**SUBJECT:** COMANCHE PEAK NUCLEAR POWER PLANT, UNITS 3 AND 4  
DOCKET NUMBERS 52-034 AND 52-035  
RESPONSE TO REQUEST FOR ADDITIONAL INFORMATION NO. 2879

**Response to Request for Additional Information No. 2879 (CP RAI #60)**

### **QUESTION NO.: 03.07.02-1**

**Figure 1:** Maximum strain for upper 500 ft of GMRS/FIRS1 profiles  $1 \times 10^{-4}$  broad-band spectra

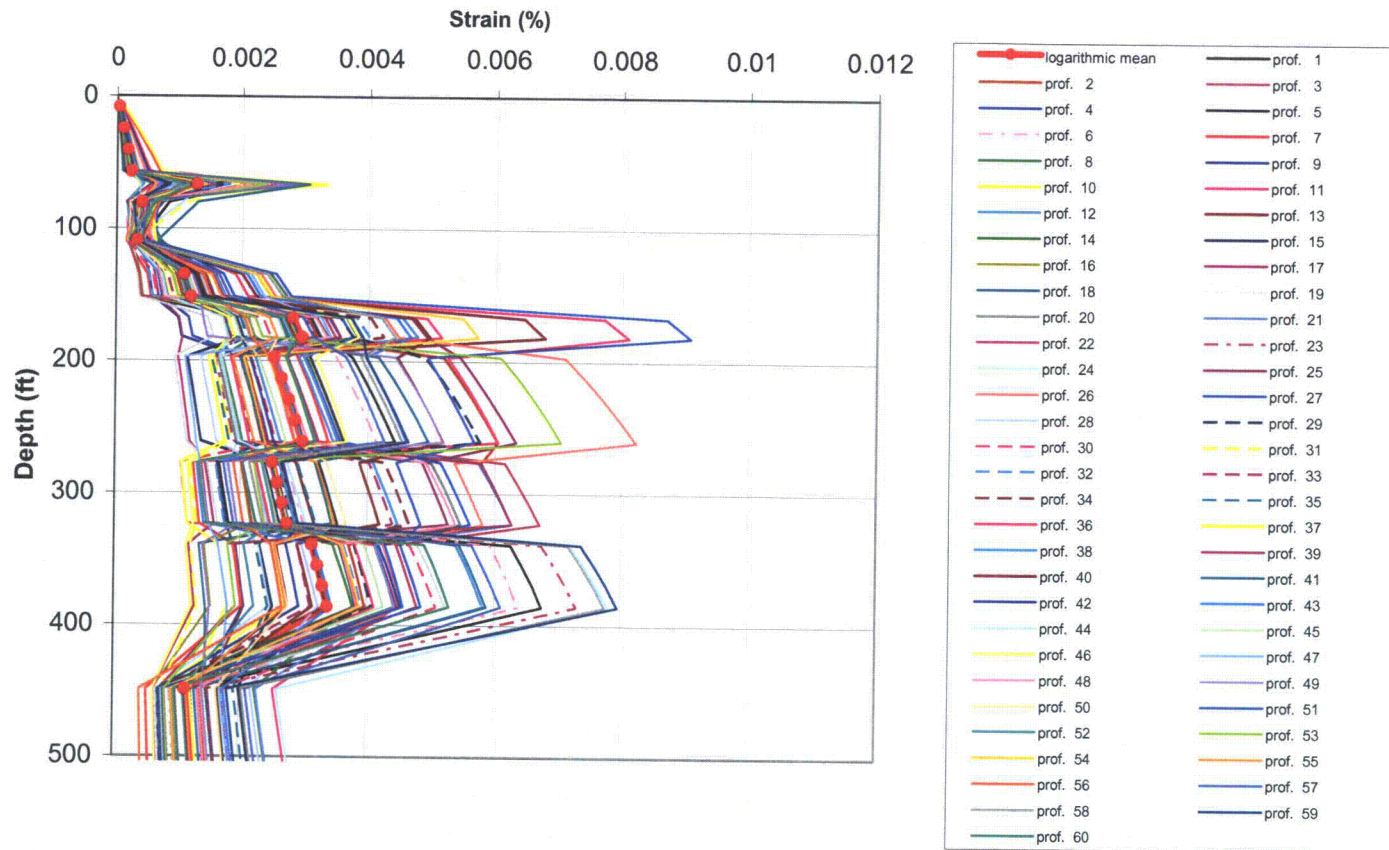
1. The name and revision of the software used for the site response analysis.
  2. The elevation at which the control motions are defined.
  3. The response spectra corresponding to the control motions.
  4. The low-strain and strain-compatible free-field properties including the shear moduli, the unit weights, the damping ratios, and the layer thicknesses for the soil column for all cases considered.
  5. The cut-off frequencies used in the analyses.
  6. The soil column natural frequencies determined from the site response analyses.
  7. The free-field amplification spectra from the site response analyses at critical elevations in the soil columns.
  8. The strain levels in the soil columns.
-

Figure 2.5.2-253 and Figure 2.5.2-254 present the peak strain in the upper 500 ft of the GMRS/FIRS1 soil column for the  $1 \times 10^{-4}$  and  $1 \times 10^{-5}$  broad band (BB) spectra, respectively. The maximum value of the logarithmic-mean strain (over the 60 synthetic profiles) in the entire GMRS/FIRS1 profile for the  $1 \times 10^{-4}$  spectrum is approximately 0.0035% and occurs at a depth of approximately 390 ft in the profile. The maximum value of the logarithmic-mean strain in the entire GMRS/FIRS1 profile for the  $1 \times 10^{-5}$  spectrum is approximately 0.0075% and also occurs at a depth of approximately 390 ft in the profile.
